American Champion Aircraft Corp.
Burlington, WI 53105

Service Letter: 458

Title: Manifold Pressure Line Upgrade

Models: 8GCBC (IO-390 install)
8KCAB (AEIO-390 install)

Fig. 458-1: Standard Manifold Pressure Line Installation (pre-Nov. 2021)

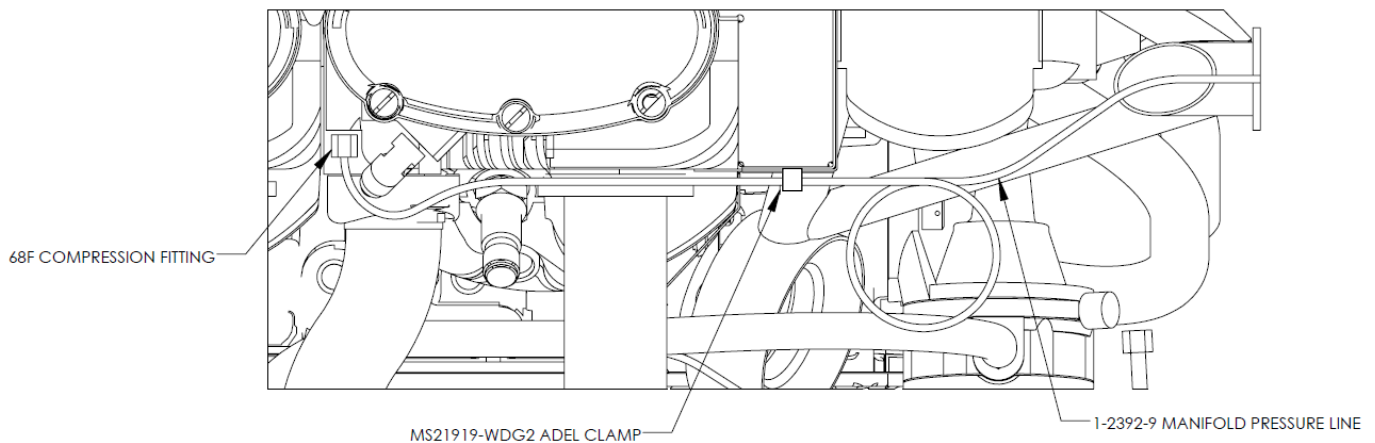
Removal of Existing Manifold Pressure Line (See Fig. 458-1)

1. Remove 1-2392-9 manifold pressure line from compression fittings.
2. Unscrew 68F compression fittings from engine and 011-04202-00 manifold pressure sensor.
3. Remove MS21919-WDG2 ADEL clamp from engine. DO NOT REMOVE THE MS21912-WDG6 ADEL CLAMP OR MAGNETO LINES.

Installation of New Manifold Pressure Line and Supporting Hardware (See Fig. 458-3)

1. OPTIONAL: Install 4034K68 snubber in 011-04202-00 manifold pressure sensor.
2. Install 4406T16 fitting in engine and 4406T21 fitting in manifold pressure sensor or snubber.
3. Install 11-1259-4 (8KCAB) or 11-1259-5 (8GCBC) manifold pressure line between fittings.

4. Install MS21919-WDG4 ADEL clamp on manifold pressure line.
5. Secure the clamp to left rear baffle with AN960-10L washer, AN365-1032 nut, and AN526C-1032-R10 screw per drawing 7-1614 (8GCBC) or 7-1617 (8KCAB).
6. Unscrew the lower left screw on the #4 cylinder head.
7. Install MS21333-98 ADEL clamp on the manifold pressure line.
8. Install AN960-416 washer (2 req'd) and ADEL clamp on cylinder head with original screw, per drawing 7-1614 (8GCBC) or 7-1617 (8KCAB). Apply Loctite 242 (opt.).
9. Secure manifold pressure line to fittings at each end with safety wire.

Fig. 458-2: Standard Manifold Pressure Line Installation (Nov. 2021 or later)

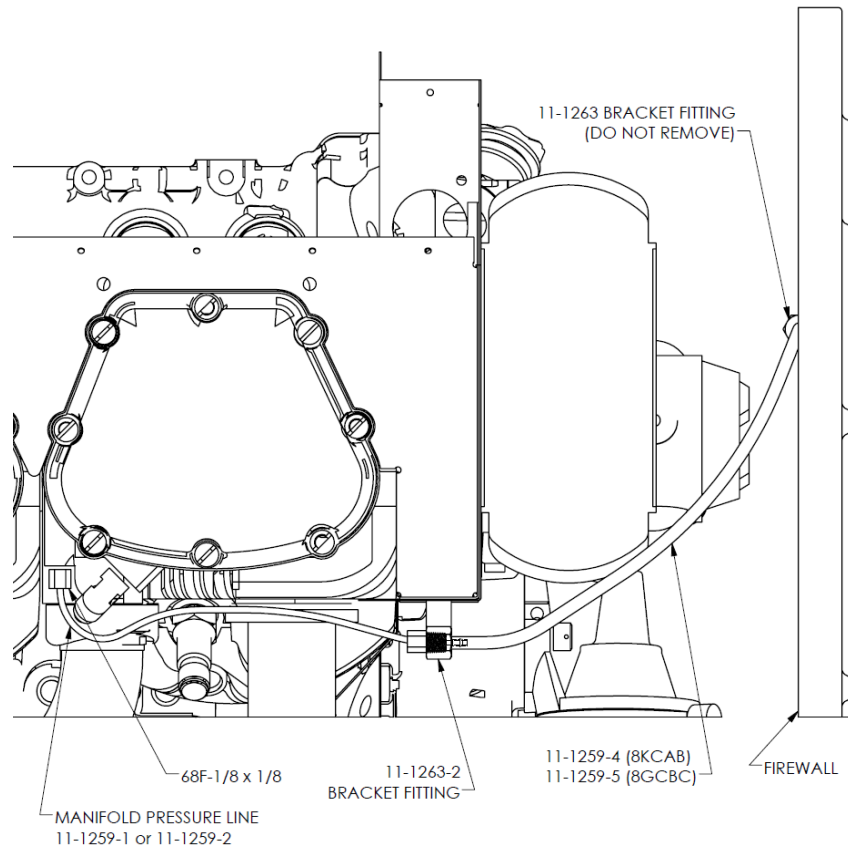
Removal of Existing Manifold Pressure Line (See Fig. 458-2)

1. Remove 11-1259-1 or 11-1259-2 copper manifold pressure line from compression fittings.
2. Unscrew 68F compression fitting from engine.
3. Remove 11-1259-3 manifold pressure line.
4. Remove 11-1263-2 bracket fitting from left rear baffle. DO NOT REMOVE THE MS21912-WDG6 ADEL CLAMP OR MAGNETO LINES.

Installation of New Manifold Pressure Line and Supporting Hardware (See Fig. 458-3)

1. Install 4406T16 fitting in engine.
2. Install 11-1259-4 (8KCAB) or 11-1259-5 (8GCBC) manifold pressure line between 4406T16 fitting and 11-1263 assembly.
3. Install MS21919-WDG4 ADEL clamp on manifold pressure line.
4. Secure the clamp to left rear baffle with AN960-10L washer, AN365-1032 nut, and AN526C-1032-R10 screw per drawing 7-1614 (8GCBC) or 7-1617 (8KCAB).
5. Unscrew the lower left screw on the #4 cylinder head.
6. Install MS21333-98 ADEL clamp on the manifold pressure line.
7. Install AN960-416 washer (2 req'd) and ADEL clamp on cylinder head with original screw, per drawing 7-1614 (8GCBC) or 7-1617 (8KCAB). Apply Loctite 242 (opt.).
8. Secure manifold pressure line to fittings at each end with safety wire.
